ACCESSION NBR: 8302280492 DOC. DATE: 83/02/24 NOTARIZED: YES DOCKET #
 FACIL: STN-50-528 Palo Verde Nuclear Station, Unit 1, Arizona Public 05000528
 STN-50-529 Palo Verde Nuclear Station, Unit 2, Arizona Public 05000529
 STN-50-530 Palo Verde Nuclear Station, Unit 3, Arizona Public 05000530
 AUTH. NAME: AUTHOR AFFILIATION
 VAN BRUNT, E. E. Arizona Public Service Co.
 RECIP. NAME: RECIPIENT AFFILIATION
 KNIGHTON, G. Licensing Branch 3

SUBJECT: Forwards revised responses to NRC Questions 210.1 & 440.3 re.
 inter-sys LOCA surveillance requirements. NRC concerns not
 applicable to plants. Proposed amended FSAR pages provide
 justification for including operating limits in Tech Specs.

Subject: Palo Verde Nuclear Generating Station
(PVNGS) Docket Nos. STN-50-528/529/530
File: 83-056-026; G.1.01.10

Attached are revised responses to NRC question Nos. 210.1 and 440.3 (PVNGS FSAR question Nos. 3A.15 and 5A.14) concerning Inter-System LOCA Surveillance Requirements. APS has re-evaluated its commitments concerning these requirements and believes that the NRC's concerns are not applicable to PVNGS.

FIGURE 1
ISOLATION CONFIGURATIONS

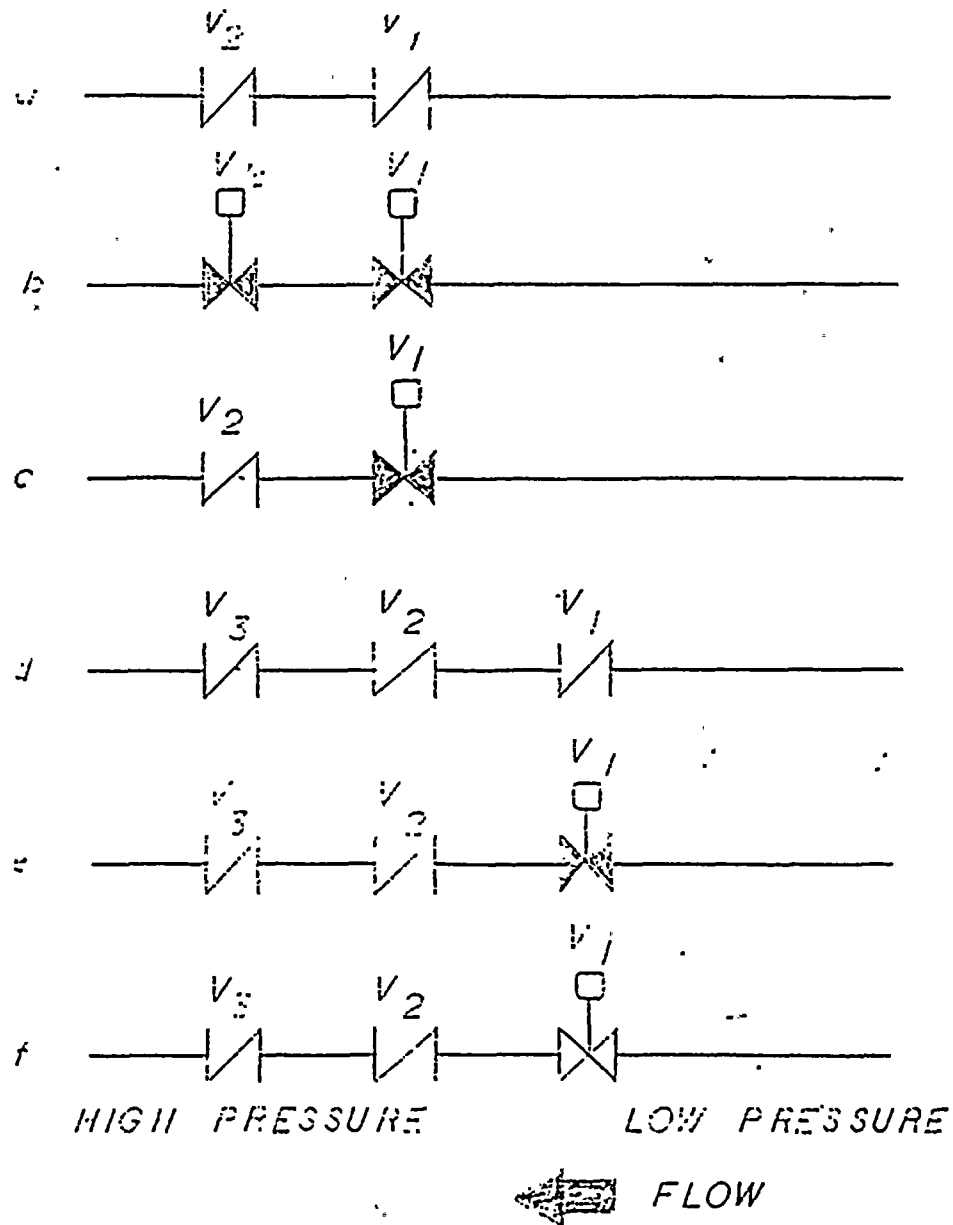
- 1) The high pressure system must be connected to the Primary Coolant System;
- 2) there must be a high pressure/low pressure interface present in the line;
- 3) this same piping must eventually lead outside containment;
- 4) the line must have one of the valve configurations shown in Figure 1; and
- 5) the pipe line must have a diameter greater than 1 inch.

FIGURE 2
 TYPICAL FOR LOOPS
 1A, 2A, 1B, 2B
 (SEE P&ID 13-M-SIP-002)

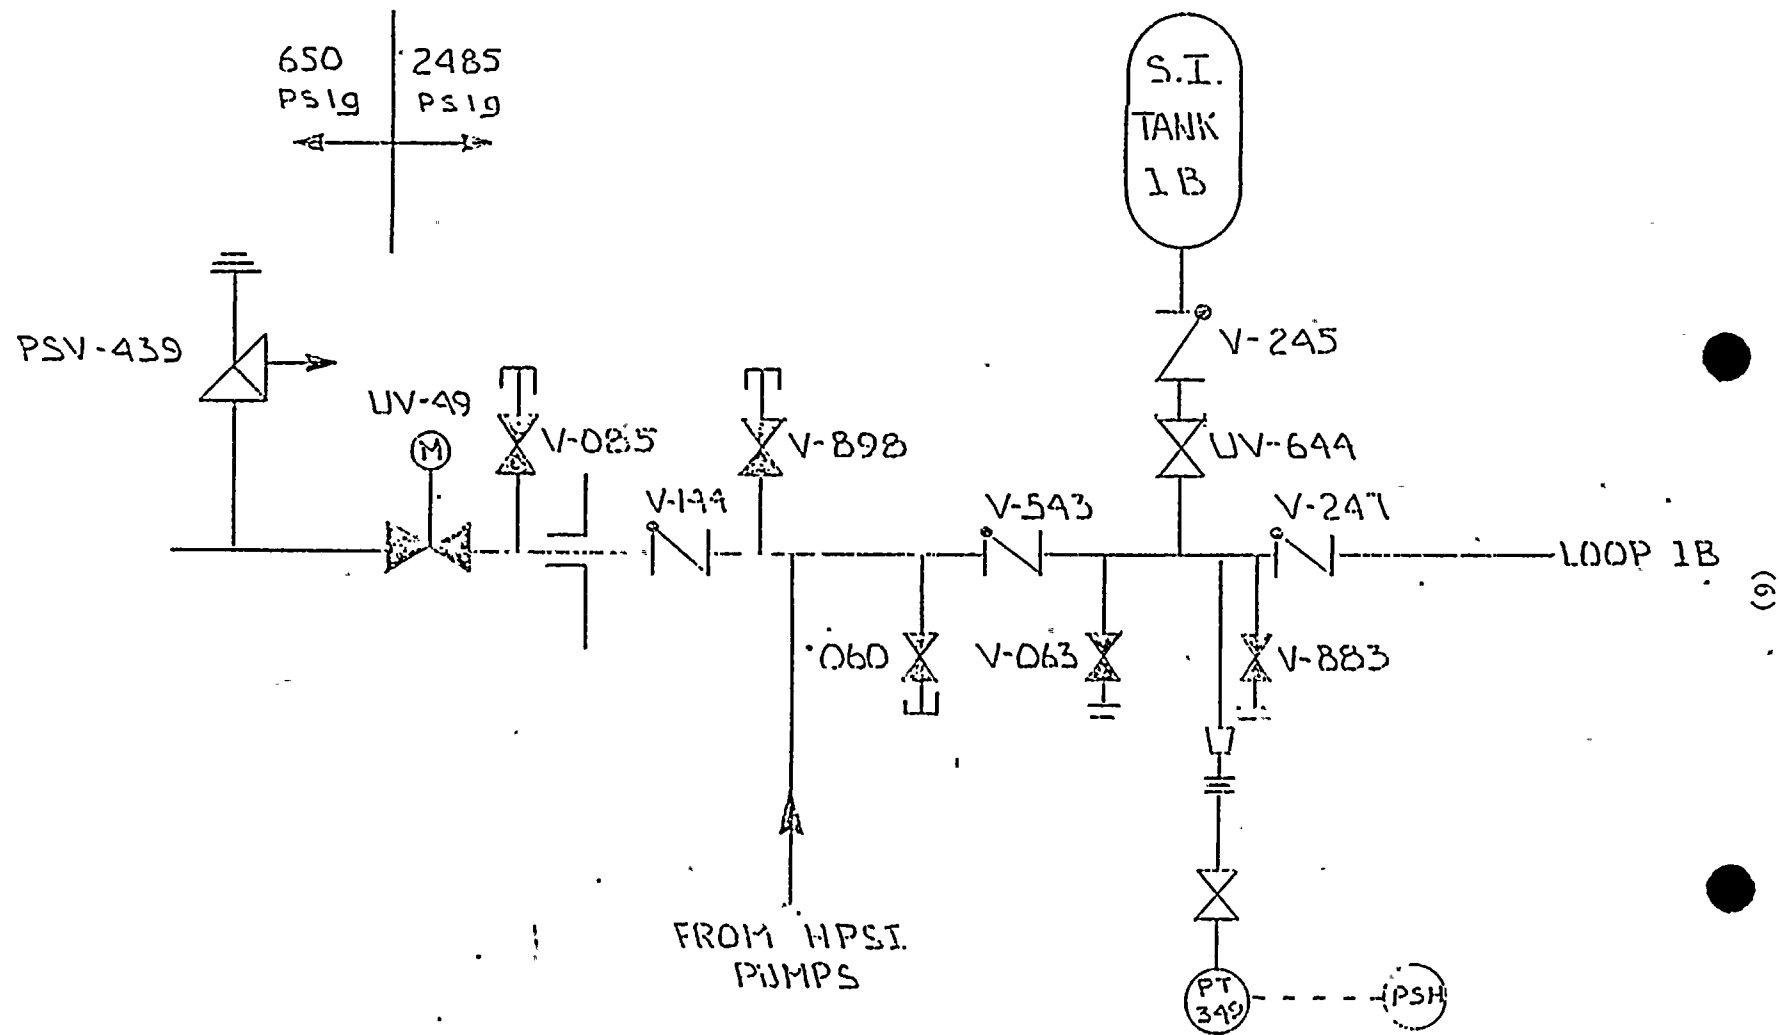
The PVNGS Low Pressure Safety Injection (LPSI) system and the High Pressure (HP) long term recirculation system were initially identified as Event V configurations. However, closer investigation proves they are not. The valve configurations for these systems, as shown in Figures 2 and 3, were evaluated to determine the probability of intersystem LOCA using the guidance contained in NUREG-0677.

The LPSI system (see Figure 2* for valve configuration) has three check valves and a motor operated valve (MOV) in series, which forms the interface between the high pressure RCS and the low pressure portion of these systems.

The check valves are assumed to fail in either of two modes - leak or rupture. In the leak failure mode, it is postulated that after the valve has been exercised it does not reseal and establish a pressure boundary. WASH-1400 assigns a probability of 2.6×10^{-3} per year per valve to this type of check valve failure. In addition to failure by the leak mode, a check valve can fail to perform its isolation function due to rupture of its disk. This instantaneous rupture was estimated by WASH-1400 to occur with a probability of 8.8×10^{-7} per year per valve.

The MOV does not exhibit the leak mode failure because the valve is under positive control by its motor operator and position indication is provided. Any small seat leakage that would occur is not expected to be large enough to cause the event. Therefore, its failure mode is rupture of the valve internals, with the probability being the same as for check valve rupture (8.8×10^{-7} per year per valve).

In addition to rupture, the MOV's could be opened by operator error during plant operations. The failure rate for the operator inadvertently opening the valve and not correcting his error has been suggested by the NRC Probabilistic Analysis Staff in NUREG-0677 to be 1×10^{-4} per year.

The probability for each of these failure modes is evaluated and the results are summed for all failure mode combinations to determine the total intersystem LOCA probability for the isolation configuration shown in Figure 2. Evaluating for the 40 year life of the plant and assuming no periodic leak testing, the failure rate is 1.75×10^{-9} per reactor year, which is well below the NUREG-0677 target value of 10^{-7} per reactor year.

In conclusion, PVNGS systems are designed toward preventing an inter-system LOCA which bypasses containment. Due to the low probability of failure, additional seat leakage testing imposed by Technical Specifications is not required.

FIGURE 3
TYPICAL FOR LOOPS: 1 & 2
(SEE P&ID 13-M-SIP-002)

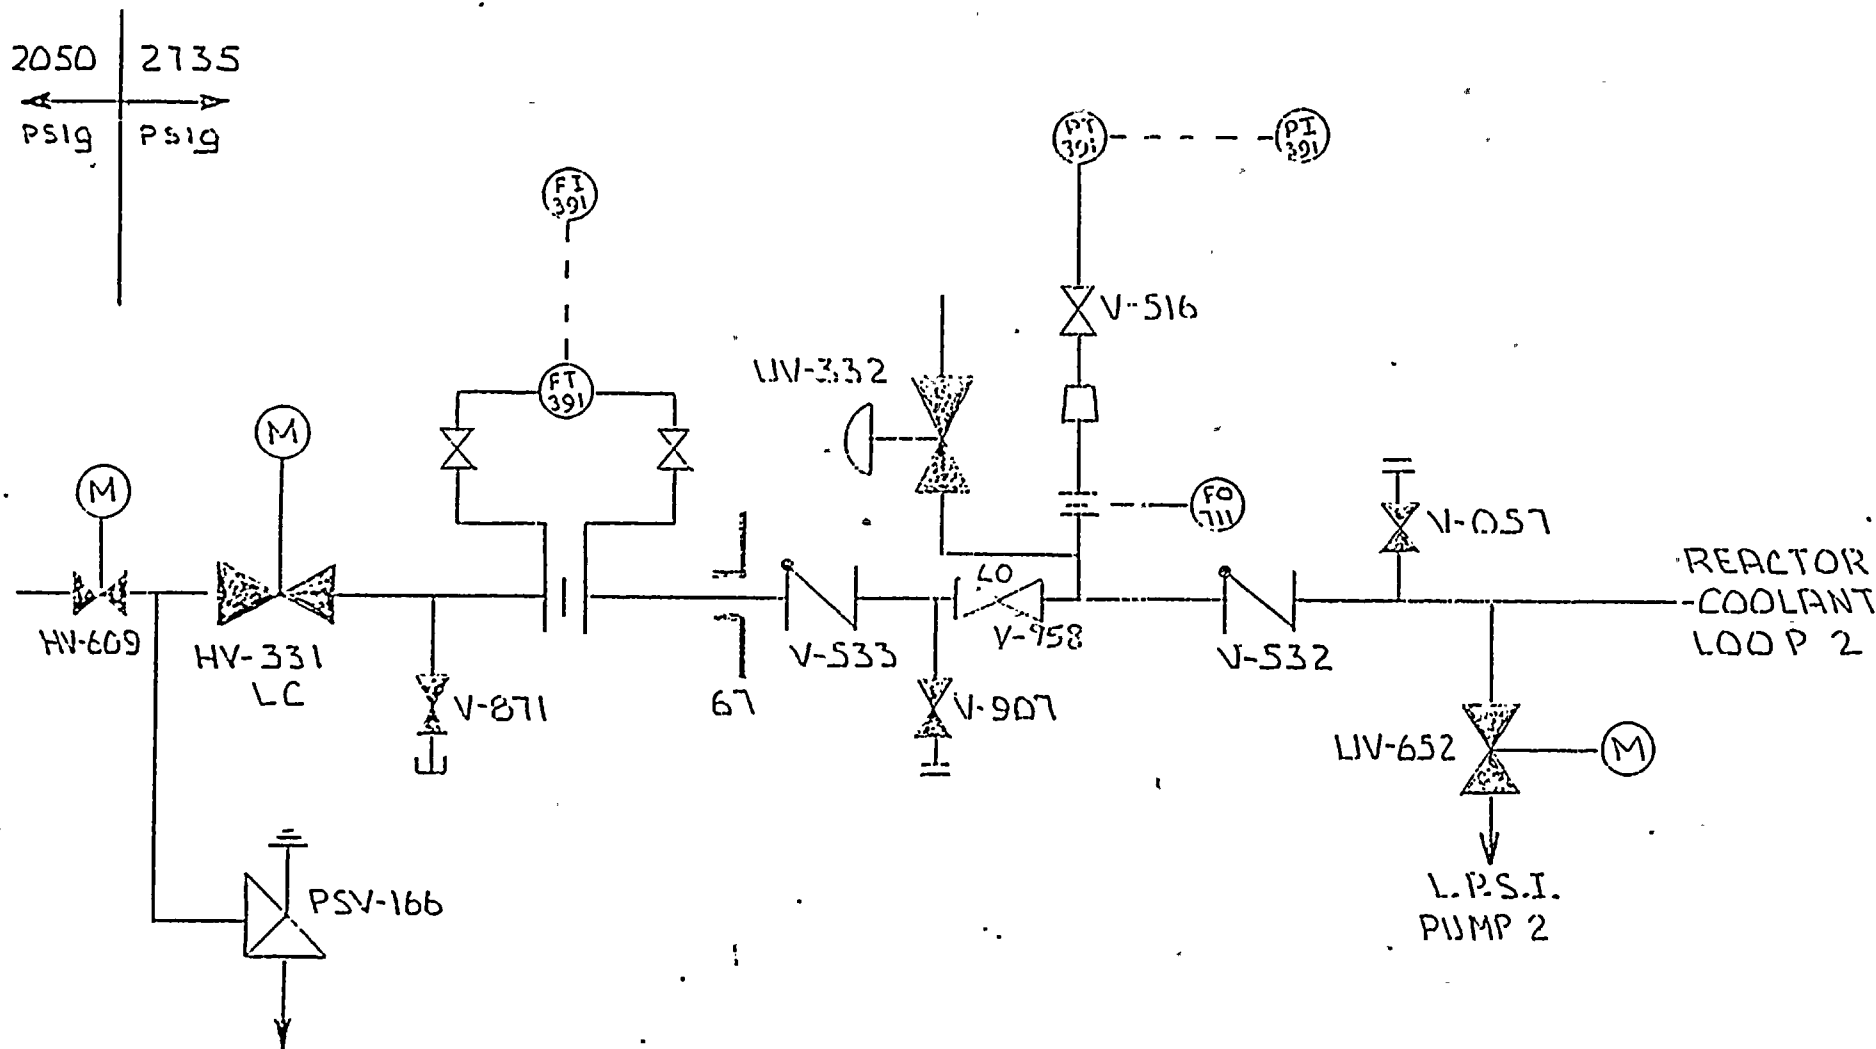
The HP long term recirculation system (Figure 3) has two check valves and two normally closed MOV's in series forming the interface between the high pressure RCS and the low pressure portion of the system. There are two operational constraints that must be considered. The configuration provides two normally closed MOV's which eliminates the impact of periodic valve stroking. Also, the double operator error failure mode (inadvertent opening of both MOV's) is eliminated by key-locking the MOV's in the closed position.

The intersystem LOCA probability for the HP long term recirculation system was evaluated for the 40 year life of the plant and assumed no periodic leak testing. The resulting failure rate is 8.79×10^{-11} per reactor year, which is substantially below the NUREG-0677 target value of 10^{-7} per reactor year.
